Memorandum

To	Marcia Christiansen - BOPRC
Copy	Vincent Murphy - Momentum
From	Sarah Millar
Office	Whakatāne
Date	17 August 2023
File/Ref	2-9Z729.01
Subject	ContainerCo Stormwater S92 Request

Option Two 011 – TPBP SW PLAN.ai includes

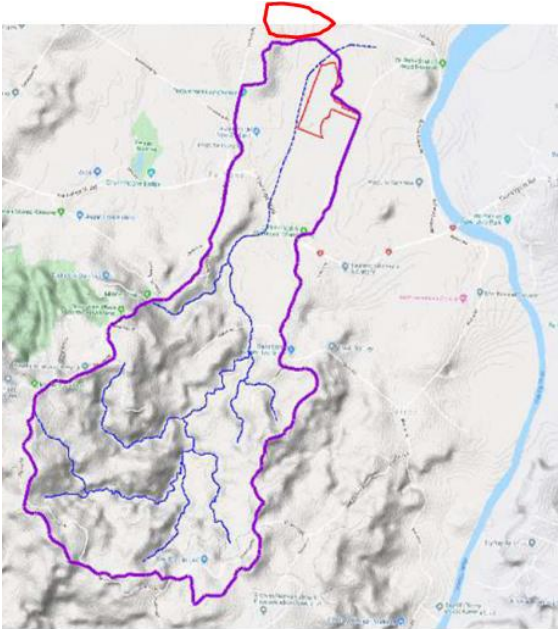
For the technical review of the application to proceed, there are certain recommendations that must be followed by the applicant. The first recommendation is to resubmit the stormwater calculations, but this time, they must consider the entirety of the catchment. Following the stormwater calculation results, an adequate stormwater management system shall also be provided.

Additionally, the applicant should also resubmit their assessment of flooding effects. This assessment should take into consideration both stormwater and coastal inundation for large events, but also more frequent events (e.g. 10% AEP event). The assessment should include the factors mentioned in the review process so far. By doing so, the applicant can provide a more comprehensive analysis of the potential impact of flooding on the proposed application together with mitigation options.

- Removal of Tinex/TPL boundary culvert (to allow stormwater from ContainerCo and upper (southern) catchment to flow towards Wairoa River via overland flow path)
- Creation of a 45 m overland flow path through the Tinex property - 30m wide overland flow path required by the structure plan.
- Installation of a third Culvert at Teihana Road – required by the structure plan (allowing floodwater from the whole catchment to flow freely to Wairoa River, rather than gathering behind the culverts)

WSP is unsure of the resulting flood levels for Option Two; Plan 011 as this exact combination of mitigation has not been covered by Steven Joynes' modelling.

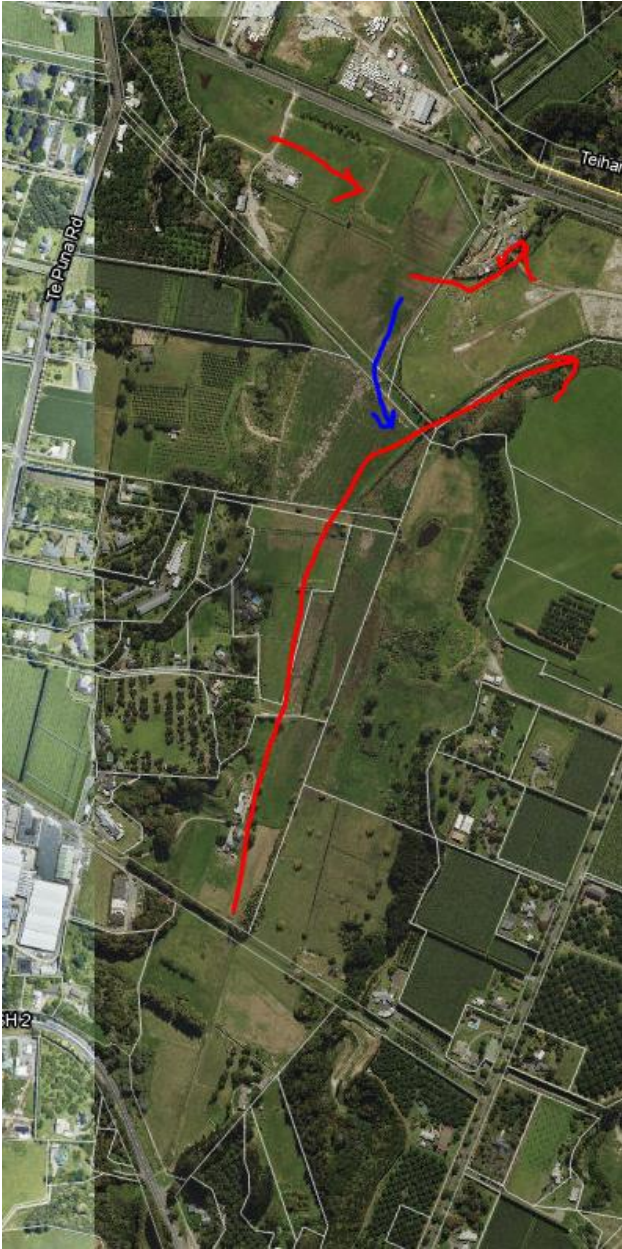
With regard to stormwater management on the ContainerCo site needing to include mitigation for stormwater from the entire upstream catchment “*stormwater calculations . . . must consider the entirety of the catchment*” and , “*the stormwater management devices are not suitable as they do not meet the capacity requirements for a larger catchment.*”

WSP’s assessment of the catchment was that it was outside of the catchment boundary identified by the technical review – the approximate ContainerCo location marked here in red;

Even if there is some flow from the larger catchment into the ContainerCo Site, the bulk of the upstream flow passes by the ContainerCo site, flowing directly down the stream. There is under some circumstances a secondary flow path from the ContainerCo site (marked below in blue) when the area downstream of the ContainerCo site is flooded, or the capacity of the small culvert on the Tenix boundary is exceeded;
